LAND AT NORTH WEST BICESTER

STAGE 1 RSA DESIGNER'S RESPONSE (A4095)

PROJECT NO. 4600/1100 DOC NO. D017

Stage 1 Road Safety Audit
Howes Lane junction with Bucknell Road, Bicester
Proposed Mini Roundabout

4.1. Problem

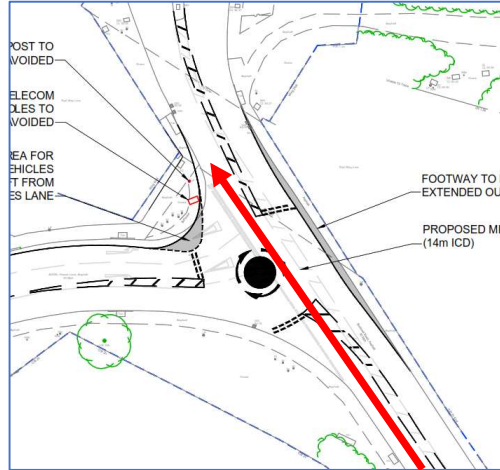
Location: On Bucknell Road – northern arm of the junction

Summary: Reduced footway width may lead to pedestrian to vehicle collisions

The realigned kerb of the northern exit arm of Bucknell Road, produces a reduced footway width on the western side of the road. The design sketch appears to show a footway width of approximately 1m. The reduced footway width may lead to pedestrians walking in the carriageway to pass others on the footway. This may lead to pedestrian to vehicle collisions. This may be exacerbated by the restricted inter-visibility between opposing pedestrians at this location, due to the railway bridge wing wall.

The reduced footway width may bring pedestrians closer to the carriageway edge, and the wing mirrors of large vehicles may overhang the footway resulting in wing mirror strikes to pedestrians.

It is recommended that measures are introduced to provide a footway width that enables opposing users to pass without entering carriageway areas; measures may include the realignment of kerb lines.

Item	Problem	Auditor's Recommendation	Designer's Response	OCC Response
4.1	<p>Location: On Bucknell Road – northern arm of the junction</p> <p>Summary: Reduced footway width may lead to pedestrian to vehicle collisions</p> <p>The realigned kerb of the northern exit arm of Bucknell Road, produces a reduced footway width on the western side of the road. The design sketch appears to show a footway width of approximately 1m. The reduced footway width may lead to pedestrians walking in the carriageway to pass others on the footway. This may lead to pedestrian to vehicle collisions. This may be exacerbated by the restricted inter-visibility between opposing pedestrians at this location, due to the railway bridge wing wall.</p> <p>The reduced footway width may bring pedestrians closer to the carriageway edge, and the wing mirrors of large vehicles may overhang the footway resulting in wing mirror strikes to pedestrians.</p>	<p>It is recommended that measures are introduced to provide a footway width that enables opposing users to pass without entering carriageway areas; measures may include the realignment of kerb lines.</p>	<p>The RSA comment on the footway amendment is noted but not accepted.</p> <p>The proposed kerbs have been aligned in order to allow for heavy goods vehicles (HGVs) and other vehicles to turn left from the A4095 Howes Lane onto Bucknell Road without incursion into the southbound lane of Bucknell Road.</p> <p>Whilst this change has reduced the effective footway width, it is noted that there is very little (if any) pedestrian demand in this location, with no pedestrians observed using this route within the traffic surveys undertaken 02/02/2022. On that basis, the likelihood of any conflict between pedestrians is minimal.</p> <p>It is also noted that the footway is reduced to a minimum of 1m for a very limited stretch, which still accords with the minimum requirements set out within Department for Transport (DfT) Inclusive Mobility Guidance (2002).</p> <p>In addition, the proposals improve the pedestrian footway provision along the eastern kerb of Bucknell</p>

<p>Road, where the greatest pedestrian demand was observed.</p> <p>On that basis, no changes are proposed to the design and if any were, it might be to remove the provision of the pedestrian footway on the western side of the Bucknell Road and the northern side of Howes Lane completely, thus preventing the opportunity for any pedestrians to utilise the crossing or the existing footway provision when there is considered to be no demand for this.</p>

4.2. Problem

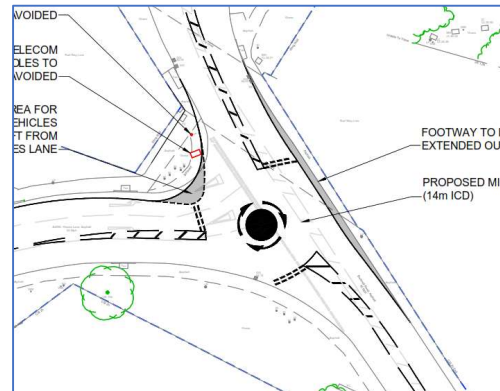
Location: At the mini roundabout, northbound travel through the junction

Summary: Excessive entry path through the junction may lead to vehicle to vehicle collisions

The offset central island location produces an excessive vehicle path through the junction for northbound users. This may lead to drivers failing to appropriately 'negotiate' the central island. Poor compliance with the circulatory requirements of the junction may lead to vehicle to vehicle collisions.

It is recommended that the size and location of the central island is amended to encourage appropriate circulatory movements for all turning manoeuvres. Measures may include a reduction in central island diameter, realignment of the eastern kerb realignment and a reduction of the circulatory carriageway width.

4.2	<p>Location: At the mini roundabout, northbound travel through the junction</p> <p>Summary: Excessive entry path through the junction may lead to vehicle to vehicle collisions</p> <p>The offset central island location produces an excessive vehicle path through the junction for northbound users. This may lead to drivers failing to appropriately 'negotiate' the central island. Poor compliance with the circulatory requirements of the junction may lead to vehicle to vehicle collisions.</p>	<p>It is recommended that the size and location of the central island is amended to encourage appropriate circulatory movements for all turning manoeuvres. Measures may include a reduction in central island diameter, realignment of the eastern kerb realignment and a reduction of the circulatory carriageway width</p>	<p>The RSA comment on the alignment of the mini roundabout is noted but not accepted.</p> <p>The current location and arrangement of the central island is to allow for access through the mini roundabout for southbound HGVs turning right onto the A4095 Howes Lane. In addition, it is considered that with appropriate signage (details confirmed at the Detailed Design stage), drivers will be notified of the new junction layout.</p>

4.4. Problem

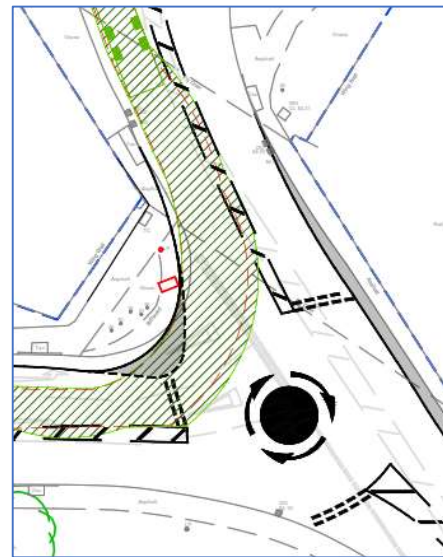
Location: At the mini roundabout –
Bucknell Road Northern entry

Summary: Late braking or failure to give
way type collisions

On the northern, Bucknell Road entry, drivers may fail to appreciate the presence of the mini roundabout, as siting of the diag 611.1 sign may be problematic and there may be reduced forward visibility to the sign. Poor perception of the change junction arrangements may lead to failure to give way or late braking shunt type collisions.

It is recommended that forward visibility to the diag 611.1 sign is maximised to provide adequate warning of the junction type. Existing map type direction signs for the conventional roundabout on the A4095 (E) and Bucknell Road (N) approaches should be amended to clearly identify the new roundabout junction at Howes Lane.

4.4	<p>Location: At the mini roundabout – Bucknell Road Northern entry</p> <p>Summary: Late braking or failure to give way type collisions</p> <p>On the northern, Bucknell Road entry, drivers may fail to appreciate the presence of the mini roundabout, as siting of the diag 611.1 sign may be problematic and there may be reduced forward visibility to the sign. Poor perception of the change junction arrangements may lead to failure to give way or late braking shunt type collisions</p>	<p>It is recommended that forward visibility to the diag 611.1 sign is maximised to provide adequate warning of the junction type. Existing map type direction signs for the conventional roundabout on the A4095 (E) and Bucknell Road (N) approaches should be amended to clearly identify the new roundabout junction at Howes Lane</p>	<p>The RSA comment on signage is noted and accepted.</p> <p>The details of the signage strategy will be agreed at the Detailed Design stage.</p>

4.5. Problem

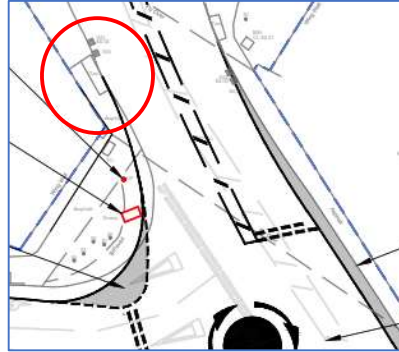
Location: At the mini roundabout

Summary: Swept path of large vehicles may
lead to vehicle to vehicle
collisions

Whilst on site, the audit team noted that the drivers of large vehicles over-ran the central hatched area and opposing traffic lane when making a left turn manoeuvre from Howes Lane on to Bucknell Road. The swept path drawings provided indicate that drivers of large vehicles may have to carry out a precise left turn manoeuvre to avoid over-running the opposing traffic lane or striking nearside kerbs. This manoeuvre may lead to vehicle to vehicle collisions with the introduction of the mini roundabout and revised kerb line of the eastern side of Bucknell Road.

It is recommended that measures should be introduced to minimise the likelihood of large vehicle swept paths crossing the hatched areas and entering the opposing traffic lane; measures may include widening the hatched markings separating the two traffic streams, reducing the southbound traffic lane width, and amending the eastern kerb line.

4.5	<p>Location: At the mini roundabout</p> <p>Summary: Swept path of large vehicles may lead to vehicle to vehicle collisions</p> <p>Whilst on site, the audit team noted that the drivers of large vehicles over-ran the central hatched area and opposing traffic lane when making a left turn manoeuvre from Howes Lane on to Bucknell Road. The swept path drawings provided indicate that drivers of large vehicles may have to carry out a precise left turn manoeuvre to avoid over-running the opposing traffic lane or striking nearside kerbs. This manoeuvre may lead to vehicle to vehicle collisions with the introduction of the mini roundabout and revised kerb line of the eastern side of Bucknell Road.</p>	<p>It is recommended that measures should be introduced to minimise the likelihood of large vehicle swept paths crossing the hatched areas and entering the opposing traffic lane; measures may include widening the hatched markings separating the two traffic streams, reducing the southbound traffic lane width, and amending the eastern kerb line</p>	<p>The RSA comment is noted but not accepted.</p> <p>The width of the existing southbound lane on Bucknell Road has been widened, with additional kerb alignment changes to the northbound lane in order to maximise the carriageway space available and prevent vehicles and HGVs travelling over the centreline.</p> <p>The proposals are considered to be the most appropriate within the constraints of the railway bridge to reduce conflict between vehicles</p> <p>The 'AutoTrack' vehicle tracking</p>

<p>software used contains safety allowances within the software, meaning in 'real life' situations a vehicle will be able to turn with greater ease and would be less onerous.</p> <p>No changes are therefore proposed to the current arrangement.</p>
